SPOKANE RIVER WATER TEMPERATURE AND DISCHARGE FLOW MONITORING PLAN

Spokane River Hydroelectric Project
FERC Project No. 2545

RE: Request for Comments and Recommendations on the Spokane River Water Temperature and Discharge Flow Validation Plan and the Spokane River Water Temperature and Discharge Flow Quality Assurance Control Project Plan, as Required by Article 401 (a) of the Spokane River Hydroelectric Project License (FERC no. 2545).

FIGURE 1. Map of the Upper Spokane River with Flow and Temperature Monitoring Stations

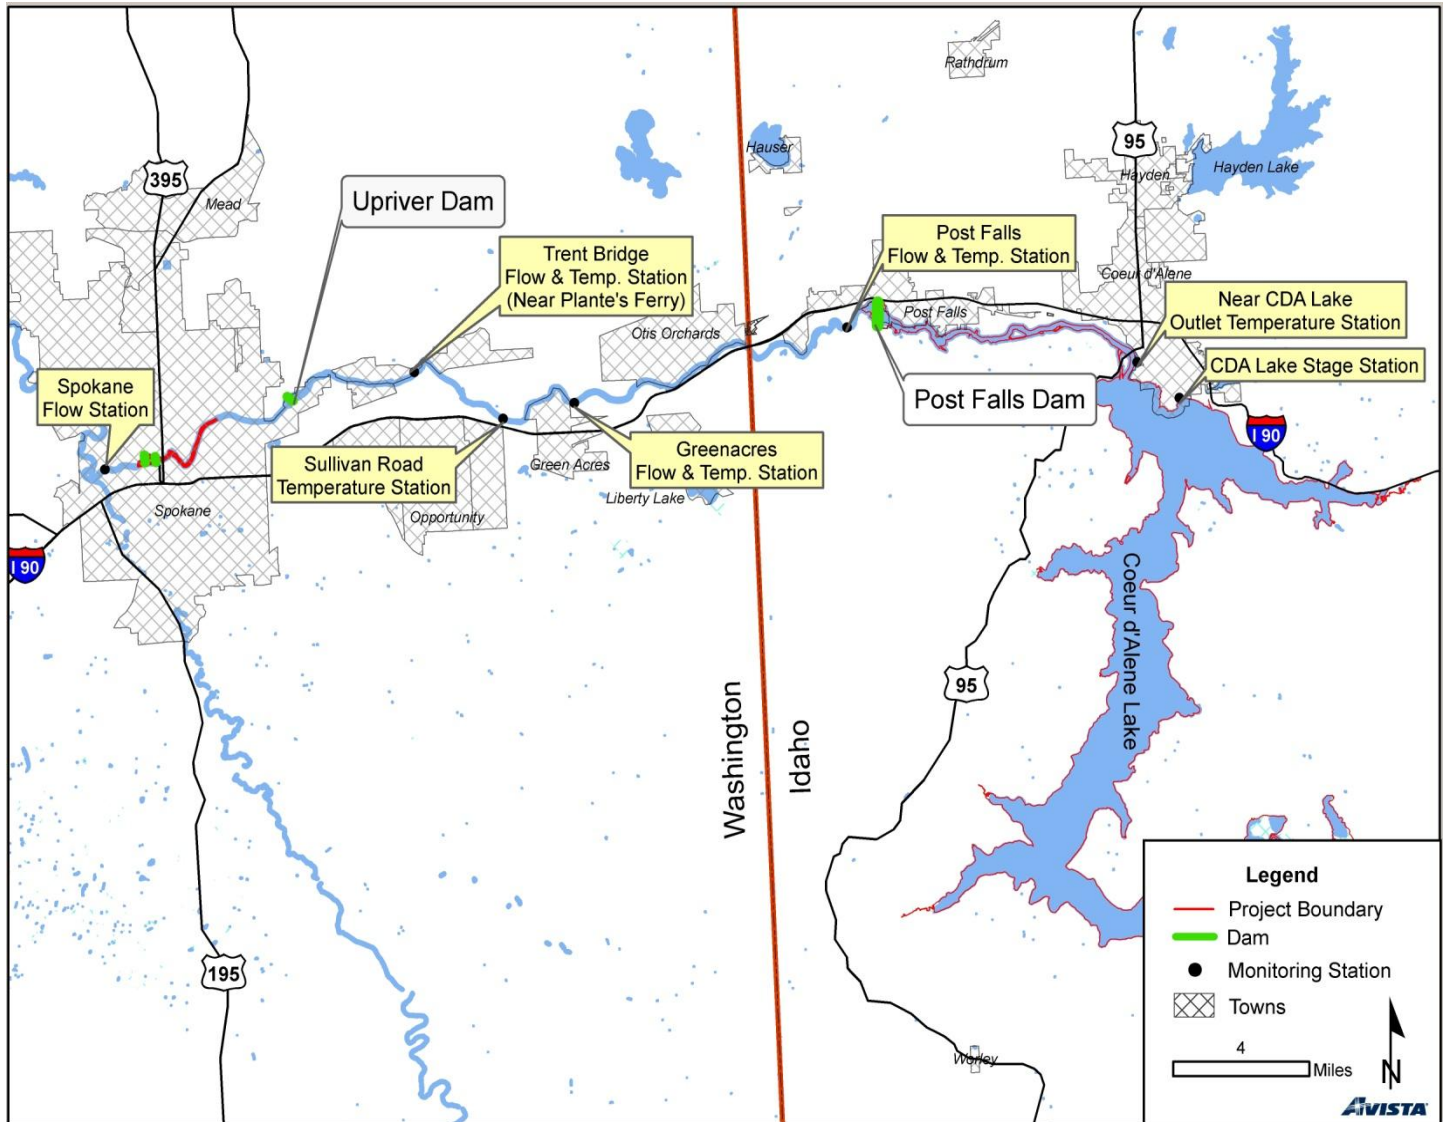
WDFW opposes the choice to monitor flow at a location 300 feet upstream of the Sullivan Road Bridge. This specific location is a transition point in the river where the aquifer input to the river begins which results in flow increases and declining water temperature. At any point above this location or below this location, the temperature and flow characteristics of the river can dramatically change. In a USGS report (Hsieh et al., 2007), seepage runs conducted in 2005 indicated the Spokane River loses water to the aquifer from Post Falls Dam to Flora Road, and that the river gains water downstream of Flora Road. Flora Road is located 1.3 miles upstream of Sullivan Road. Gregory and Covert (2005) measured stream-water temperatures to detect ground-water discharge to the river and found the river gains water below Sullivan Road causing river temperatures to rapidly decrease (see figure below from Gregory and Covert, 2005). Depending on the year and season, locations of ground-water inputs to the river and temperature influences vary at the Sullivan Road location (Hsieh et al., 2007).

Due to the variability of significant ground-water influence around Sullivan Road and because flow data is not going to be collected at this location, WDFW requests that the Sullivan Road monitoring location be omitted from the Monitoring Plan. The value of data from this monitoring location is not indicative of overall habitat characteristics in the Spokane River immediately above or below this location, and therefore this data should not be factored into decision making. We request that the Monitoring Plan focus on collecting flow *and* temperature data in the Spokane River at the other locations included in the Monitoring Plan. The locations near Post Falls Dam, Greenacres, Trent Bridge, and Spokane should provide data representative of river conditions generally found in those reaches. We request temperature data be collected at the Spokane monitoring location and believe the data collected here would be of value.

WDFW opposes the choice to monitor flow at a location 300 feet upstream of the Sullivan Road Bridge. WDFW requests that the Sullivan Road monitoring location be omitted from the Monitoring Plan.

Flow will not be monitored at a location 300 feet upstream of the Sullivan Road Bridge. However, monitoring of water temperature at the Sullivan Road location will remain in the Plan. The Sullivan station is at the same location where water temperature data was previously collected and reported in Avista Environmental Affairs Memorandum, Spokane River Temperatures, August 24, 2004, and the Graphs of Instream Flow Scenario Results, Presentation and Handouts, Robert Anderson, Golder and Associates, August 2004. In order to “evaluate the data assumptions upon which the required discharge flows are based” it is critical that we collect data from the same location that our data and assumptions were originally gathered. This area of the Spokane River is the furthest upstream site where changes in flow are known to affect water temperatures and is necessary to understand the relationship between flow and temperature. WDFW concerns regarding groundwater inputs and temperature variability at the Sullivan Road location is addressed in the QAPP section 4.1.4 under representativeness.
